ADDENDUM NO. 3

DATE: March 13, 2020

OWNER: Howard County Public School System

PROJECT: Hammond High School Renovation and Addition
Columbia, Maryland
Architect Project No. 18011

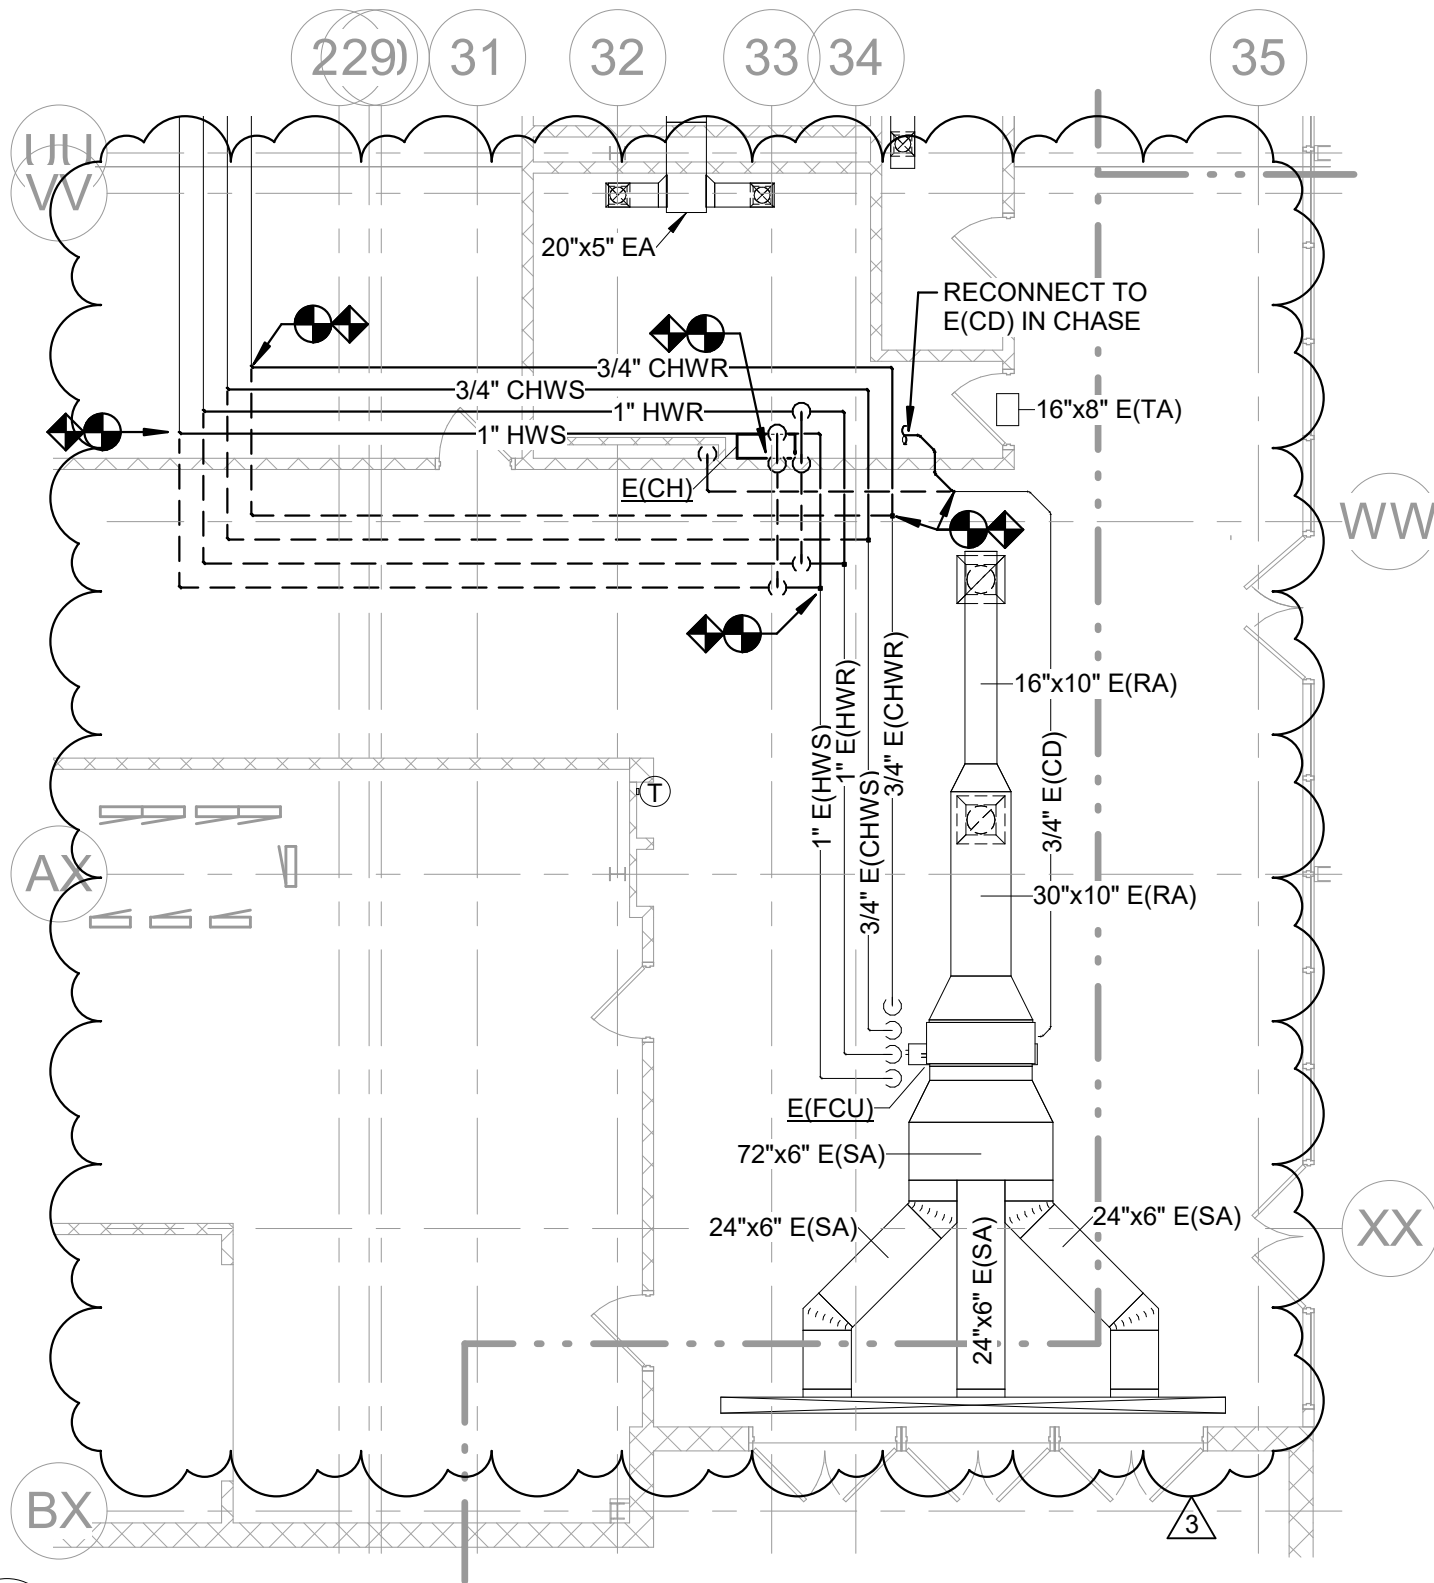
- ❑ Sheet M1.01 – FIRST FLOOR PLAN – MECHANICAL DEMOLITION PHASING
 - **ADD** Callout Box 4-M2.10 to Existing Corridor adjacent to Existing Science Wing/Media Center. See addendum drawing AD-M19.
 - **ADD** Callout Box 3-M2.11 to Existing Main Entry Lobby. See addendum drawing AD-M18.
- ❑ Sheet M2.10 – TEMPORARY CONDITIONS – MECHANICAL

- **ADD** FIRST FLOOR PLAN – CORRIDOR TEMP CONDITIONING – MECHANICAL view to sheet. See addendum drawing AD-M19.
- Sheet M2.11 – TEMPORARY CONDITIONS – MECHANICAL

ITEM:
FAN COIL TEMPORARY PIPING - EXISTING LOBBY

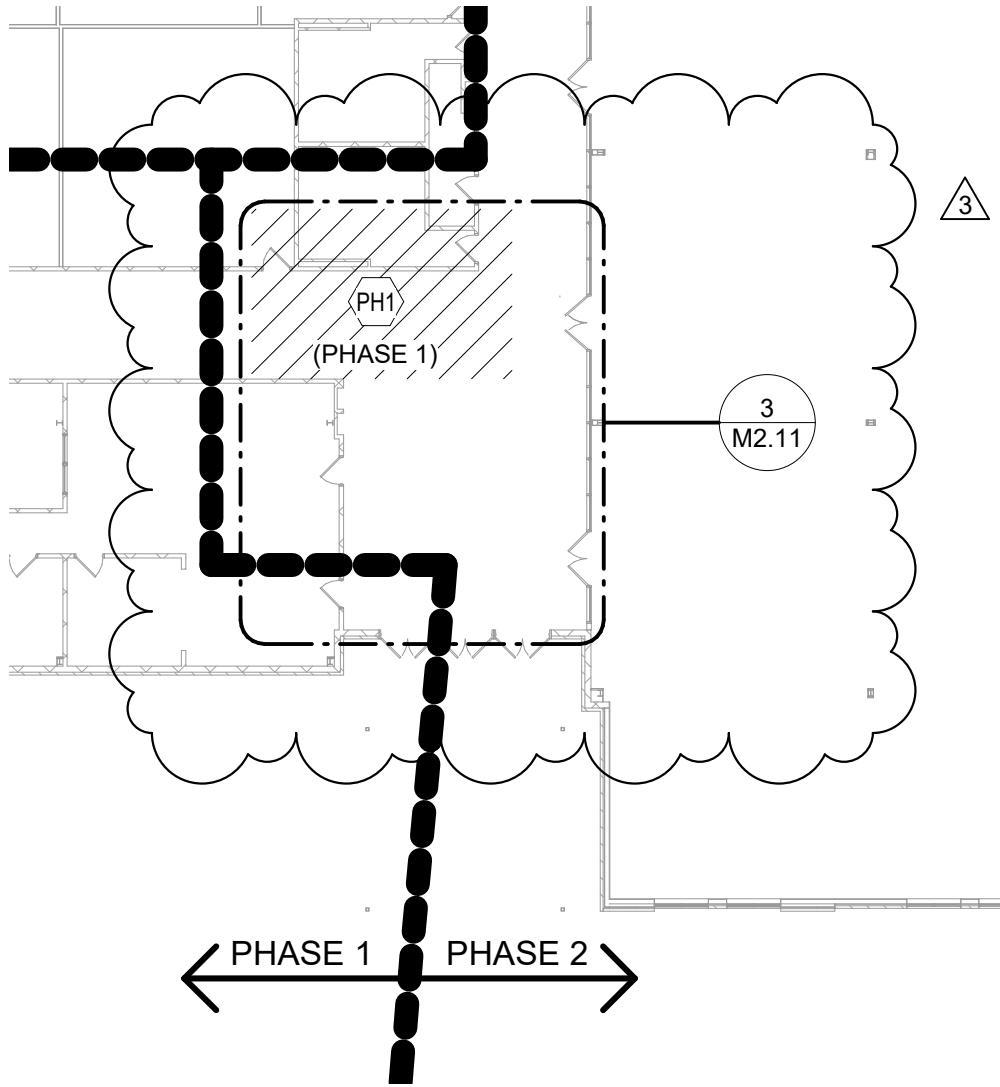
- **ADD** FIRST FLOOR PLAN – LOBBY FAN COIL TEMPORARY PIPING – MECHANICAL view to sheet. See addendum drawing AD-M17.
- Sheet M3.02 – FIRST FLOOR PLAN – AREA B – MECHANICAL

REF SHT NO.: M5.03

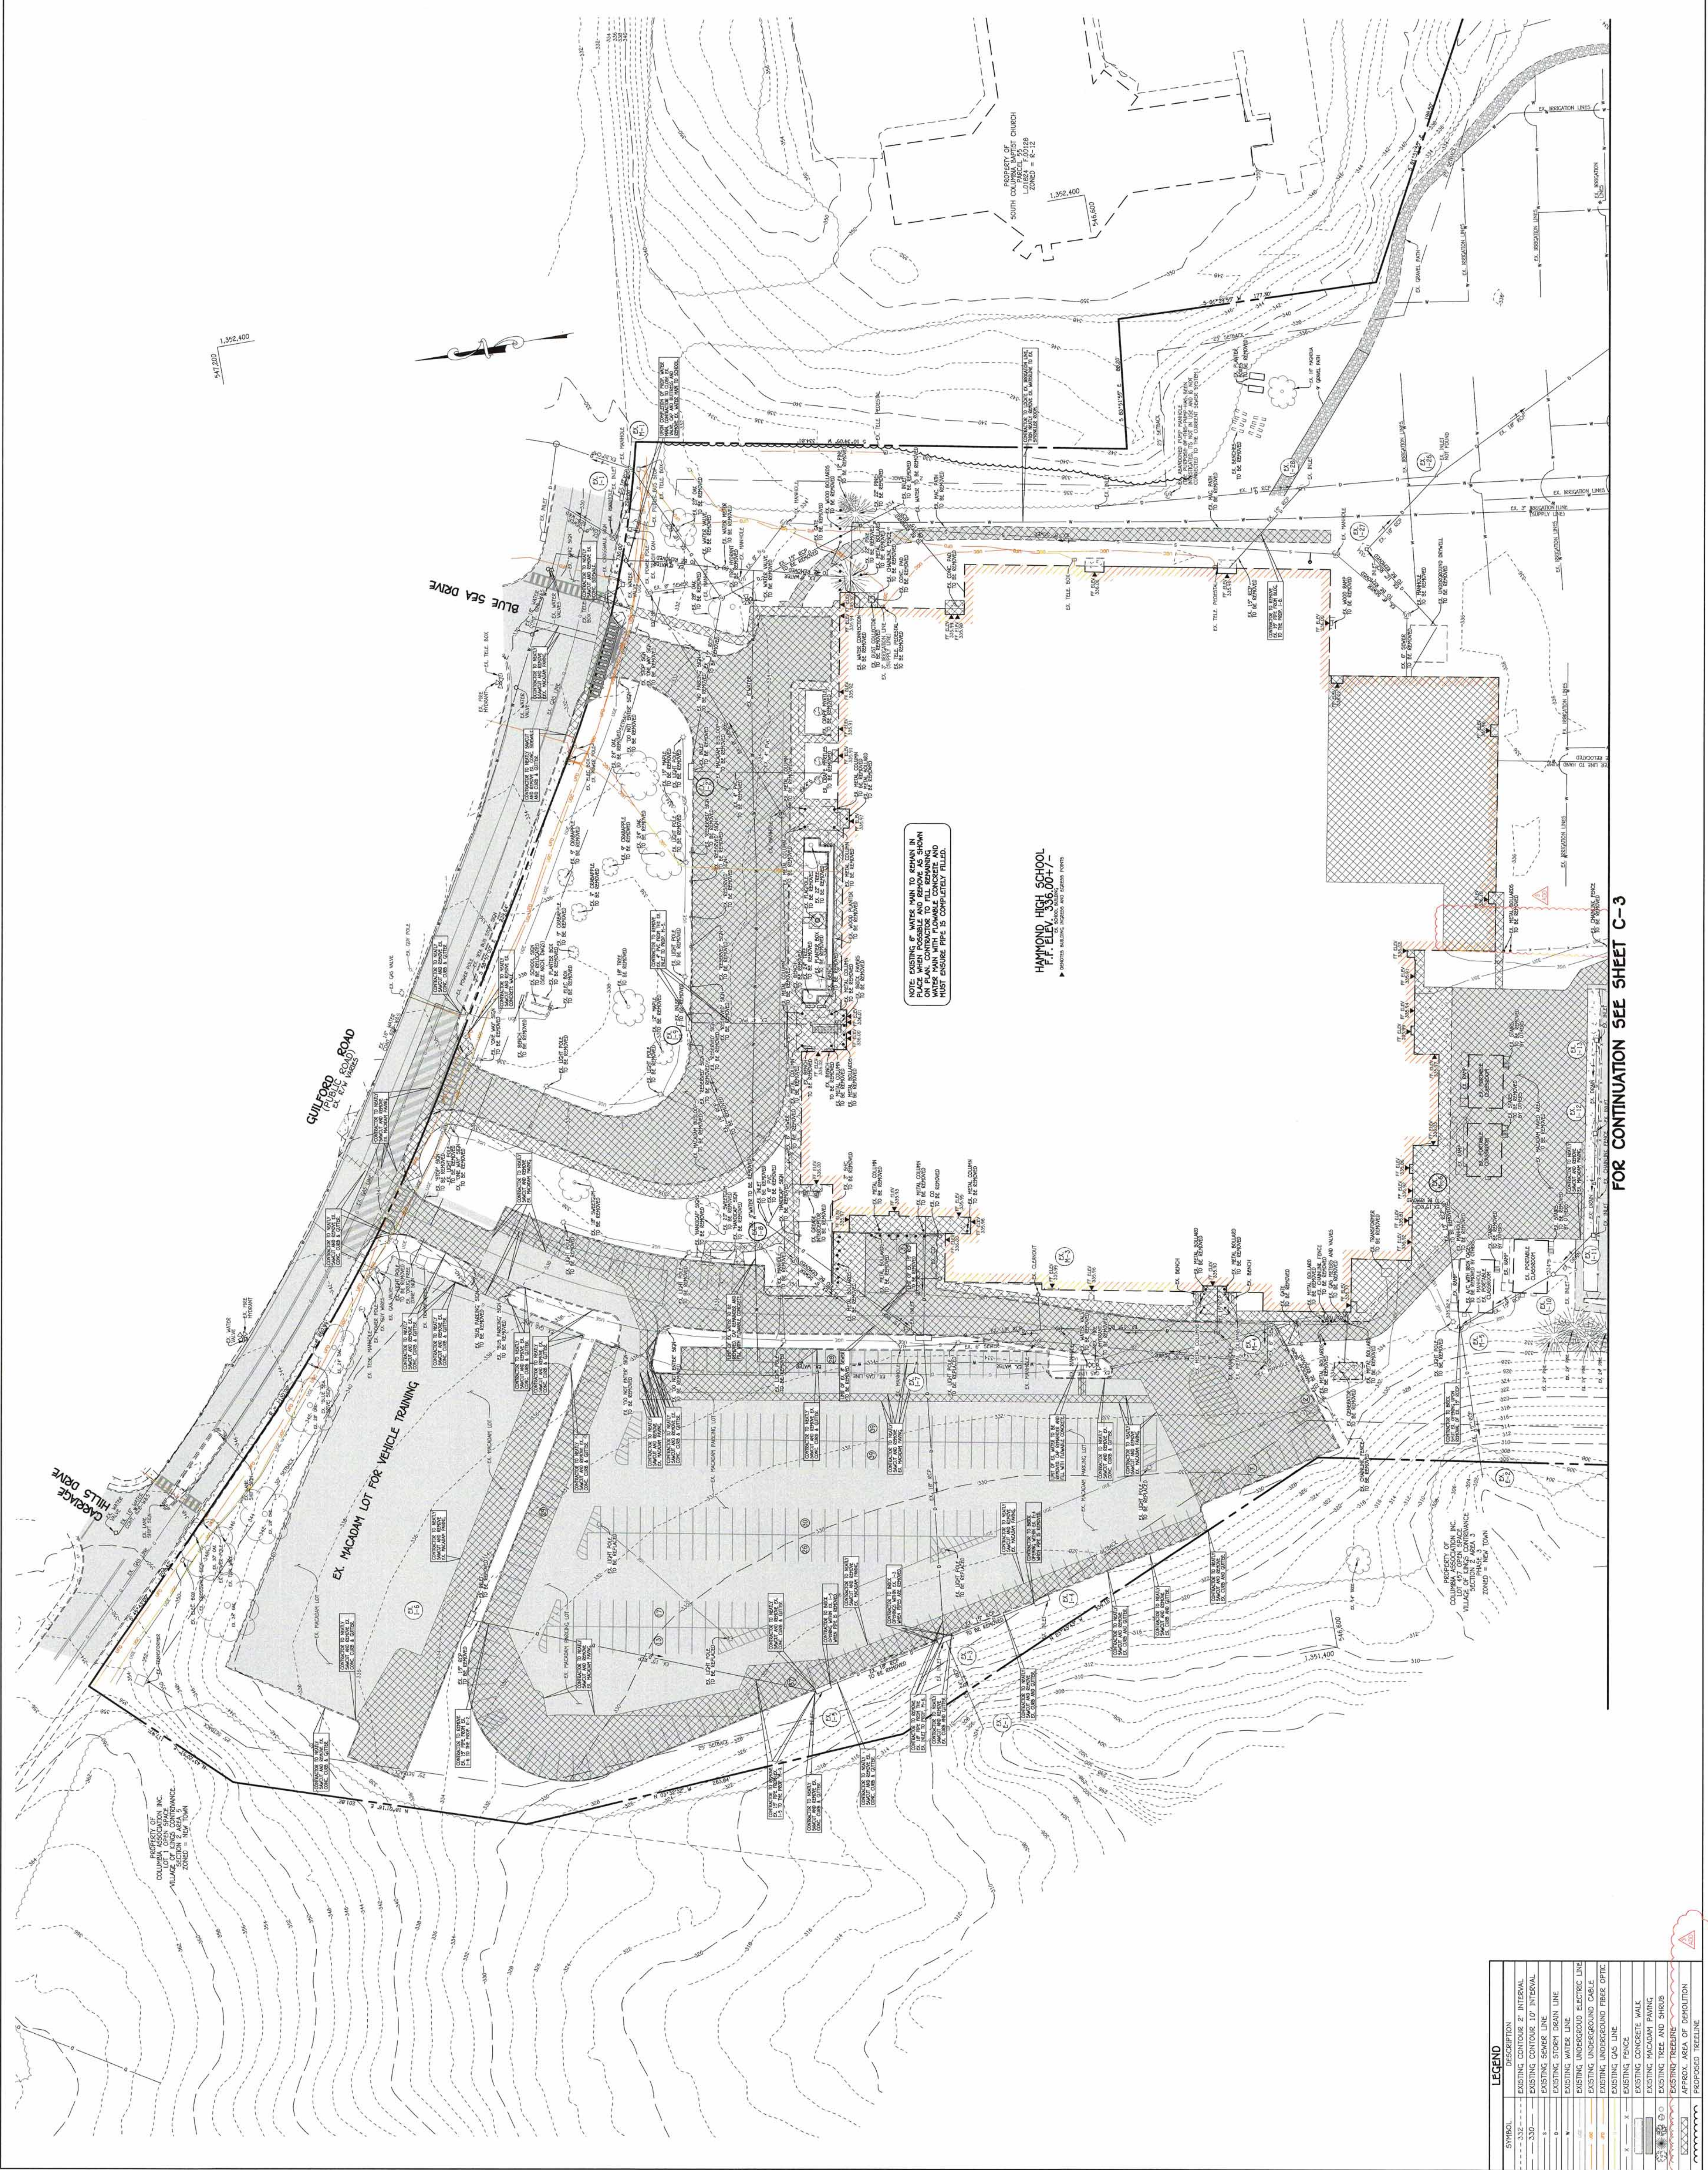
- **ADD** Pot Feeder to HOT WATER PIPING SCHEMATIC. See addendum drawing AD-M21.
- Sheet M5.03 – MECHANICAL PIPING SCHEMATICS
 - **ADD** Water Treatment Control Panel and sampling tubing to CONDENSER WATER PIPING SCHEMATIC. See addendum drawing AD-M22.

P1.02

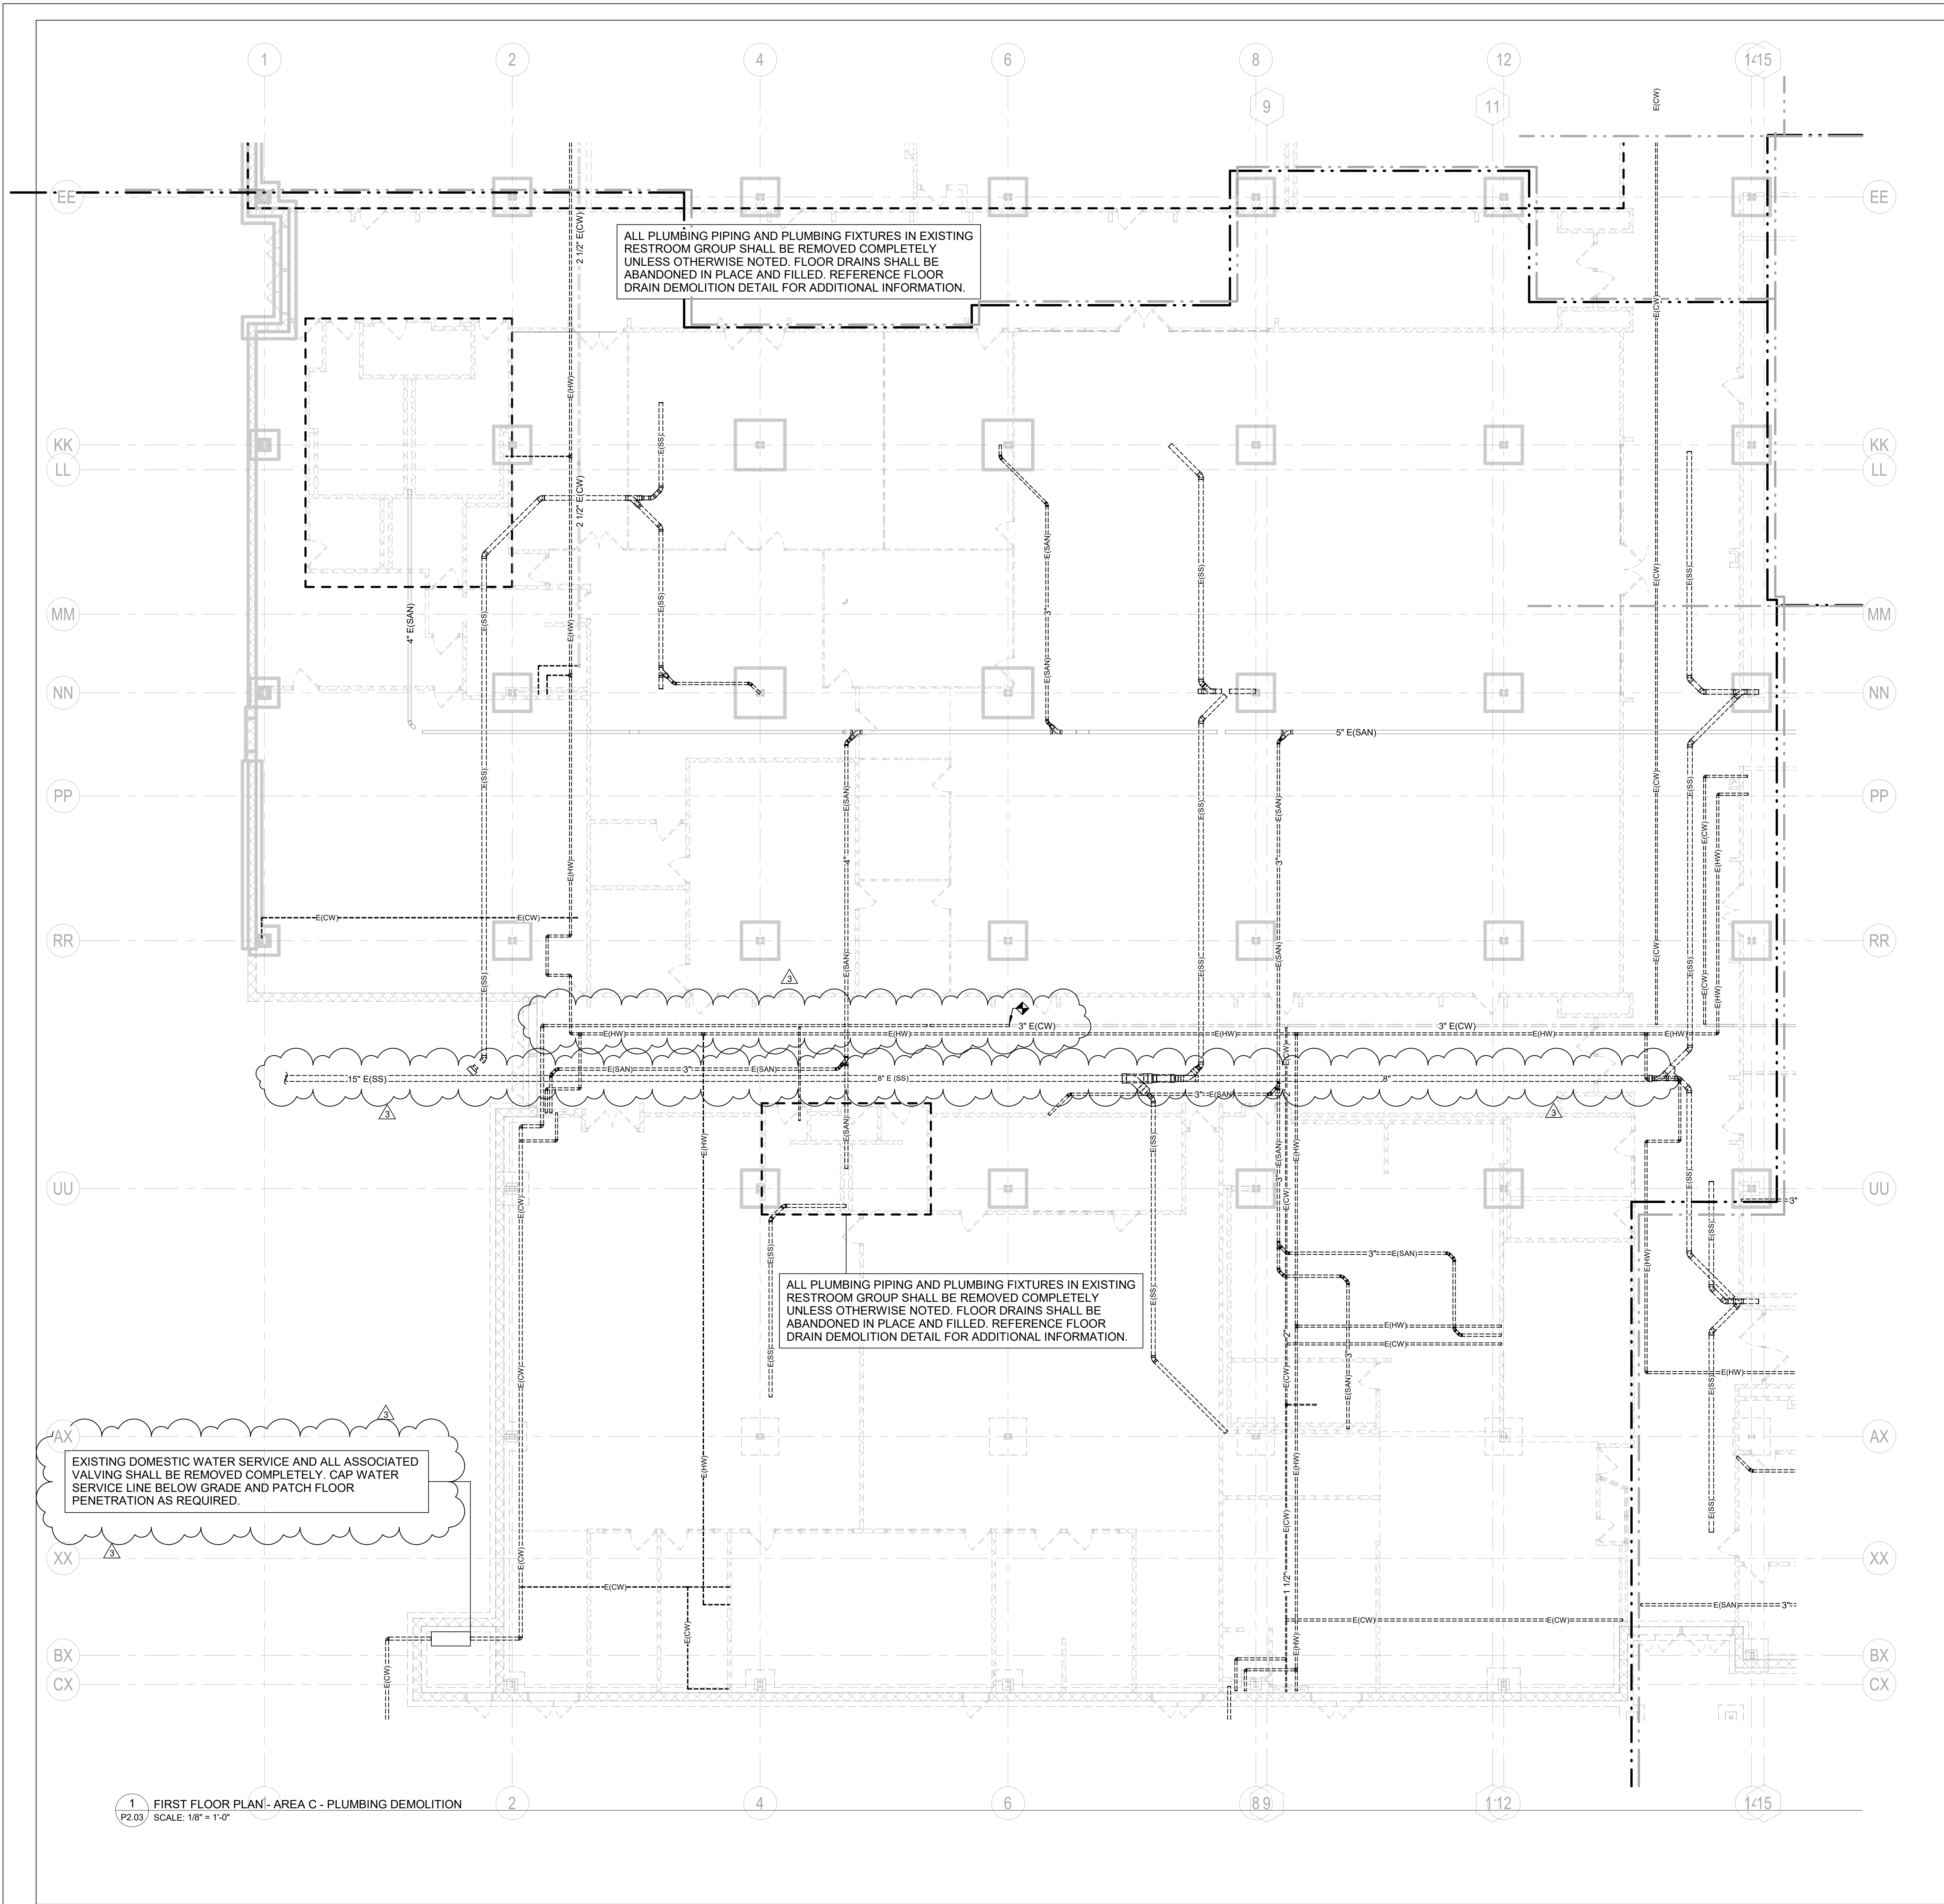
- **REPLACE SHEET:** Added detail “Modular building water entry and meter detail”. Moved “Exterior gas pressure regulator detail” from sheet P1.01, to P1.02.
